SERVICE INSTRUCTION

The firmware on the AdaptaFlow Node Adapter (P/N A10159-01) has been changed. Starting with version 1.9, SW2-5 should be "ON" (up) for AdaptaFlow racks with 3 or 4 channel cards (1/2 logical rack). For racks with one or two channel cards, the switch remains "OFF" (1/4 logical rack). (See diagram for location.)

Figure 5: Node Adapter

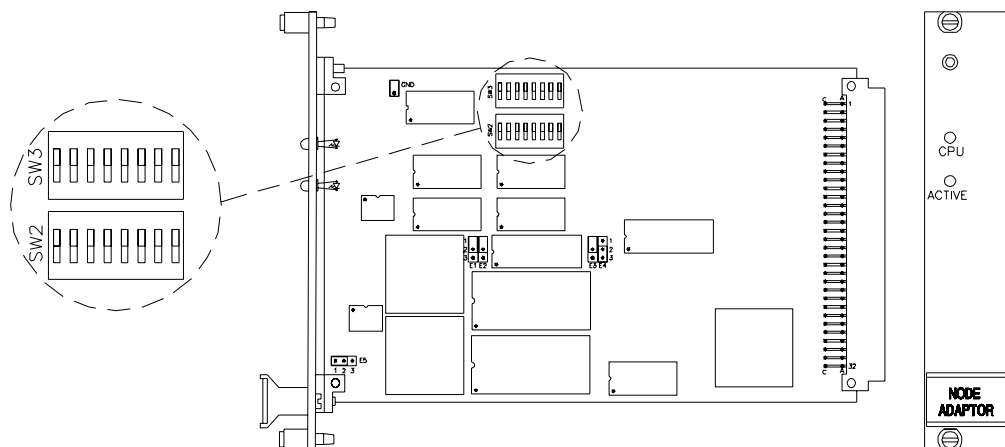
Previously, the Node Adapter polled the channel cards to determine what rack size it should be. In certain cases of failure, the Motherboard or the Channel card could cause the Node Adapter to set the rack size incorrectly.
